**[Docket No. FAA-2017-0640; Directorate Identifier 2017-CE-020-AD; Amendment 39-18969; AD 2017-15-09]**

**Airworthiness Directives; Diamond Aircraft Industries GmbH Airplanes**

**ACTION:** Final rule; request for comments.

Figure 1 to paragraph (f)(1)(ii) of this AD:  
 Sequence of Actions for Exhaust Clamp Installation of  
 DAI Work Instruction WI-MSB 42-120, Revision 3, dated July 6, 2017

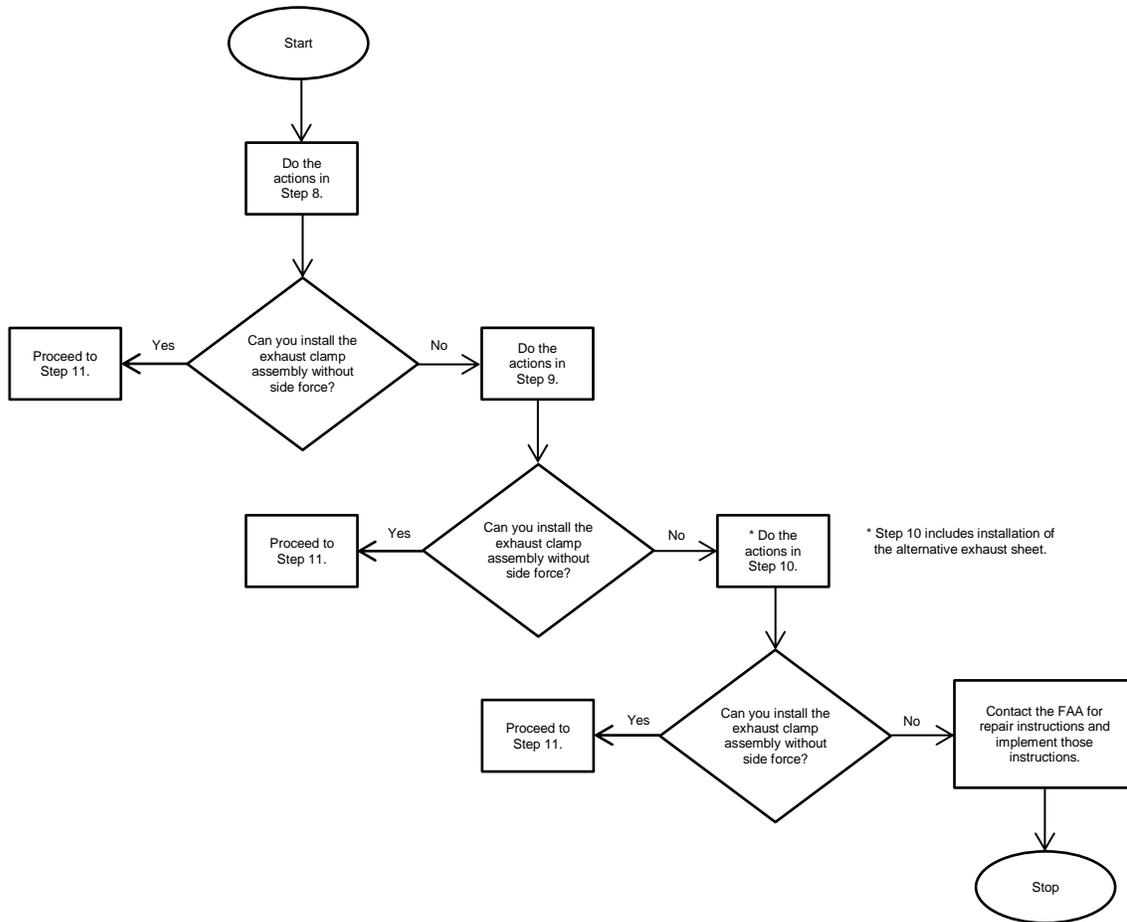
(ii) Reinstall any uncracked clamp or replace with a new clamp and incorporate spring washers following III.2 Action 2 – installation of additional exhaust clamp in the INSTRUCTIONS section of DAI Work Instruction WI-MSB 42-120, Revision 3, dated July 6, 2017, as specified in DAI Mandatory Service Bulletin MSB 42-120/2, dated June 7, 2017. See figure 1 to paragraph (f)(1)(ii) of this AD for additional information on the sequence of installation actions as identified in DAI Work Instruction WI-MSB 42-120, Revision 3, dated July 6, 2017. Credit is not given for installation of an engine exhaust clamp installed following DAI Work Instruction WI-MSB 42-120, Revision 1, dated December 14, 2016, (installation of exhaust clamp without spring washers), or DAI Work Instruction MSB-42-120, Revision 2, dated June 7, 2017.
